WeAct

Title	MiniF4 Bottom marked V2.0	
Size A3	Number	Revision V2.0
Date: 2019/11/22/Fri		Sheet of
File: E:\AD\..\MiniF4x1Cx.SchDoc		Drawn By: zhuyix

STM32 Power Section

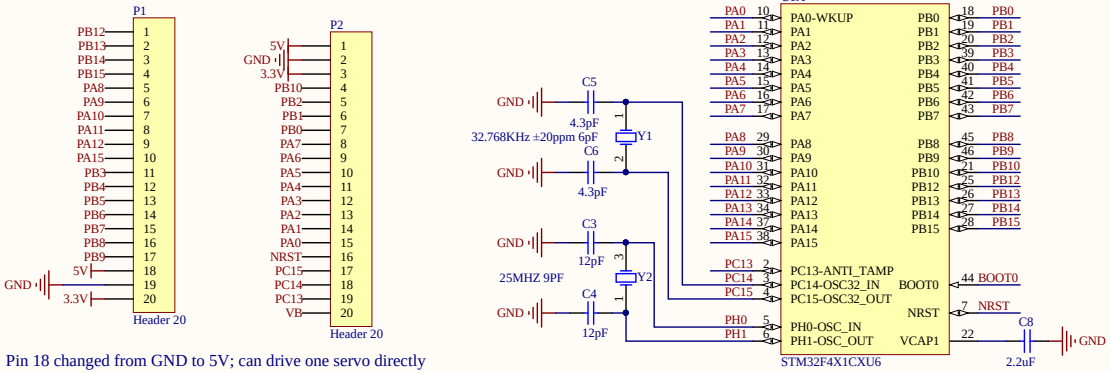
V1.1 Pin 18 changed from GND to 5V; can drive one servo directly
